UNITED STATES
DEPARTMENT OF THE INTERIOR
BUREAU OF LAND MANAGEMENTFORM APPROVED
OMB NO. 1004-0137
Expires: January 31, 2018**SUNDRY NOTICES AND REPORTS ON WELLS**
*Do not use this form for proposals to drill or to re-enter an abandoned well. Use form 3160-3 (APD) for such proposals.***SUBMIT IN TRIPLICATE - Other instructions on page 2**

GCU 314

San Juan County, NM / API 30-045-24731

Re: Permanent Abandonment
Well: Gallegos Canyon Unit 314

Wellbore Diagram

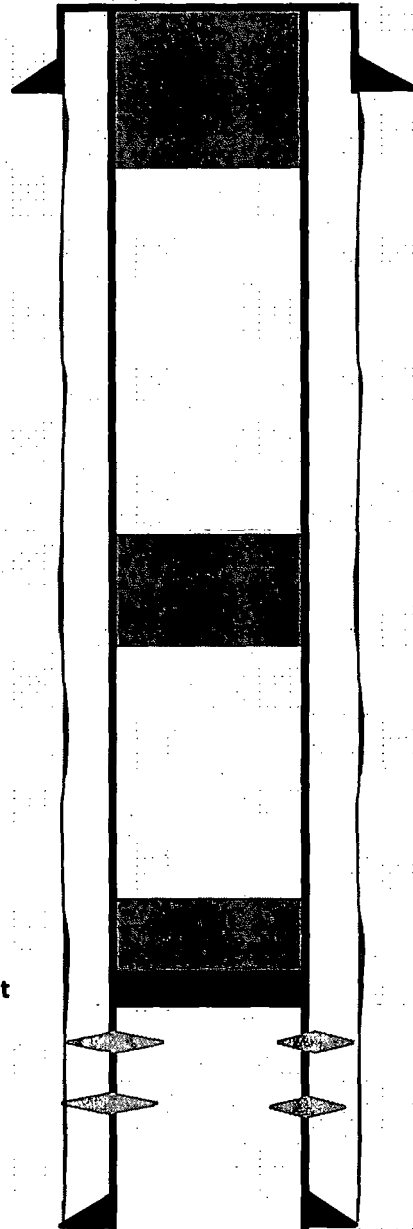
1. Plugging operations authorized are subject to the attached "General Requirements for Permanent Abandonment of Wells on Federal and Indian Lease."
2. Farmington Office is to be notified at least 24 hours before the plugging operations commence (505) 564-7750.
3. The following modifications to your plugging program are to be made:
 - a) Set plug #2 (1188 - 1088) ft. to cover the Fruitland top. BLM picks top of Fruitland at 1138 ft.
 - b) Set plug #3 (280 - 0) ft. to cover the Kirtland top. BLM picks top of Kirtland at 230 ft.

Operator will run a CBL to verify cement top. Submit the electronic copy of the log for verification to the following addresses: jwsavage@blm.gov Brandon.Powell@state.nm.us

You are also required to place cement excesses per 4.2 and 4.4 of the attached General Requirements.
